PERMIT

SEWAGE DISPOSAL SYSTEM

SUBDIVISION Woodford's Grant II LOT 6 ROAD 11425 Barley Field Way

PLAN TO ACCOMPANY APPLICATION FOR
 BUILDING PERMIT
WOODFORD'S GRANT II
 SECTION 1, AREA 1
 LOT 6

A 57555 E

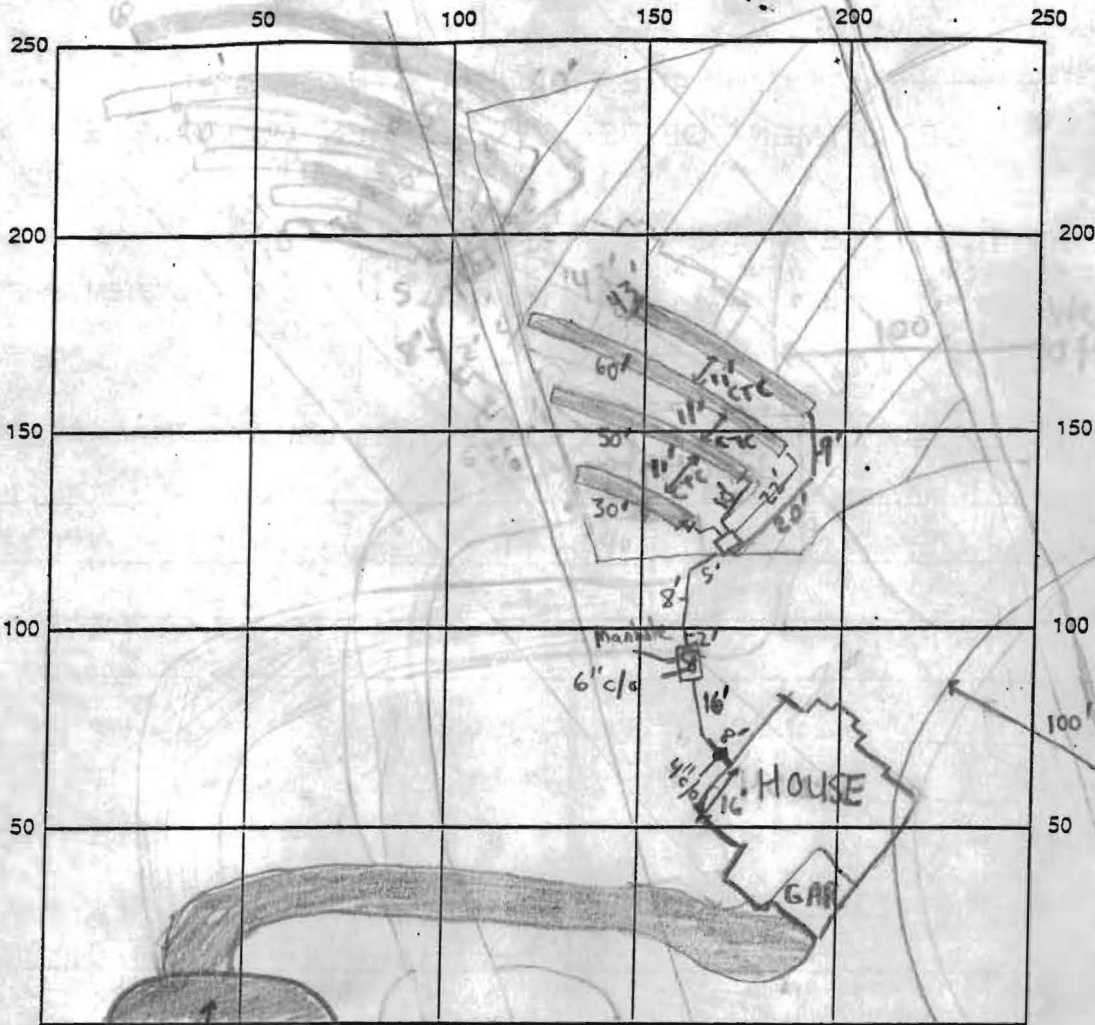
REMARKS: 7/8/99 - OK TO CONTINUE WORK (SRW) 7/9/99 - WELL MAY NOT BE ON THE LOT, SPOKER TO BUILDER IN FIELD (SRW)
7/9/99 - OK TO COVER (SRW)

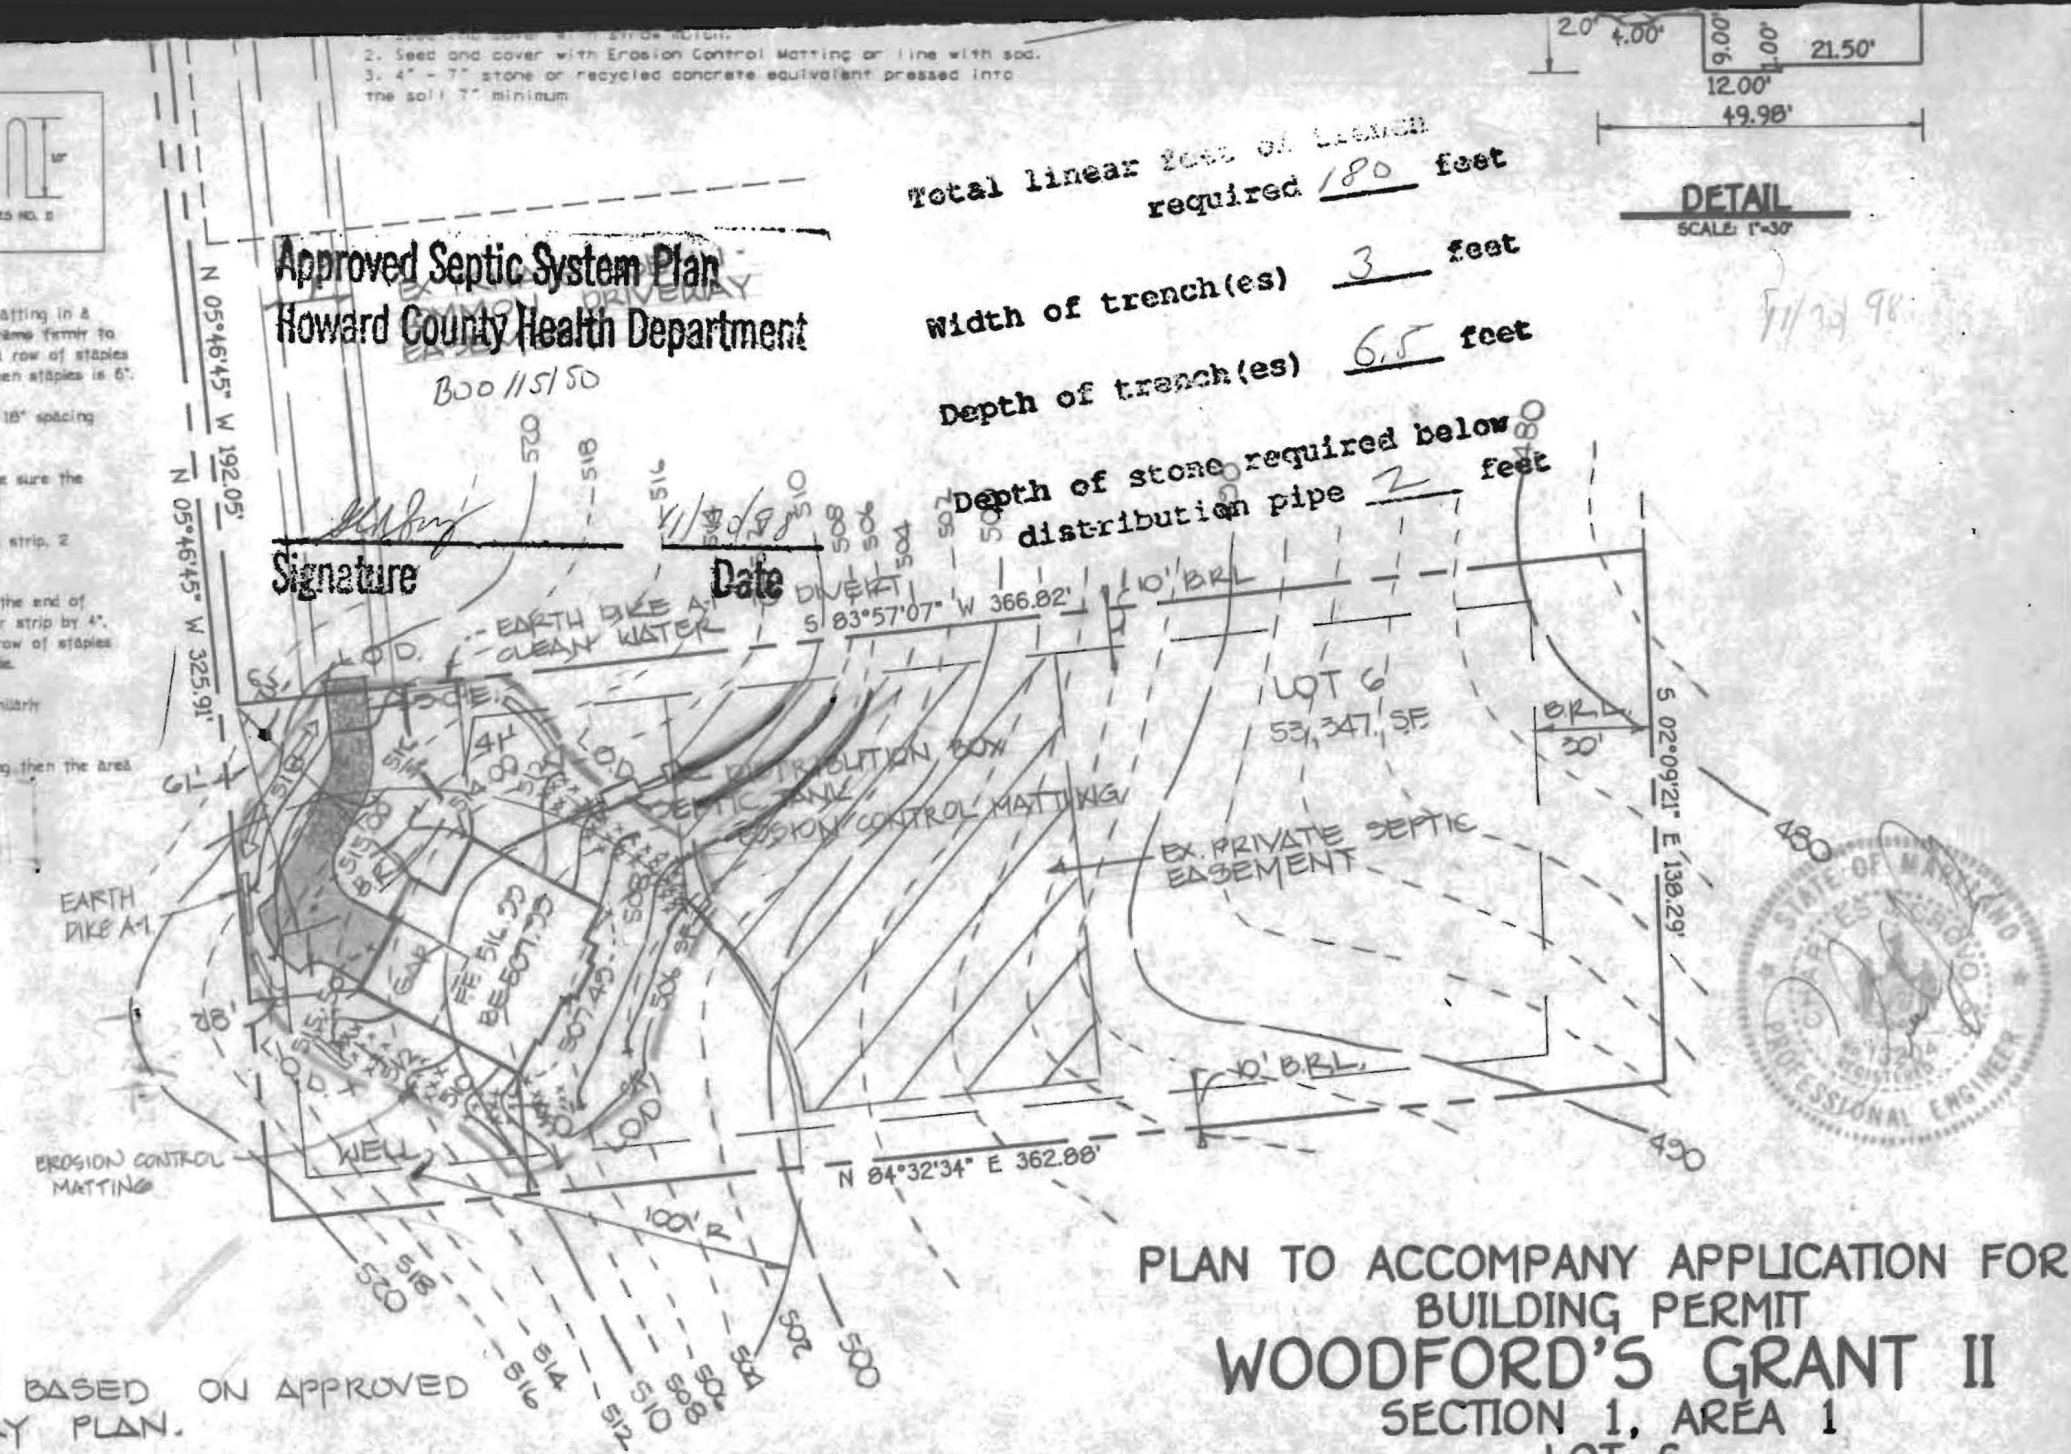
This is to follow up on our brief discussion in the field concerning the possibility of the well for the above referenced property not being located on the above referenced lot.

Field measurement find the well to be approximately 95 feet from the house. The certified location drawing (wall check) suggests any location 95 feet in that direction from the house would be off of the lot.

You mentioned that you would contact the engineer who staked the well site. Please report to us your findings on this issue.

The original planned location of the well was to be on the lot, and every effort should be made to see that it is. The Health Department would consider a request for an off-site easement only when the above requested action can not be accomplished.
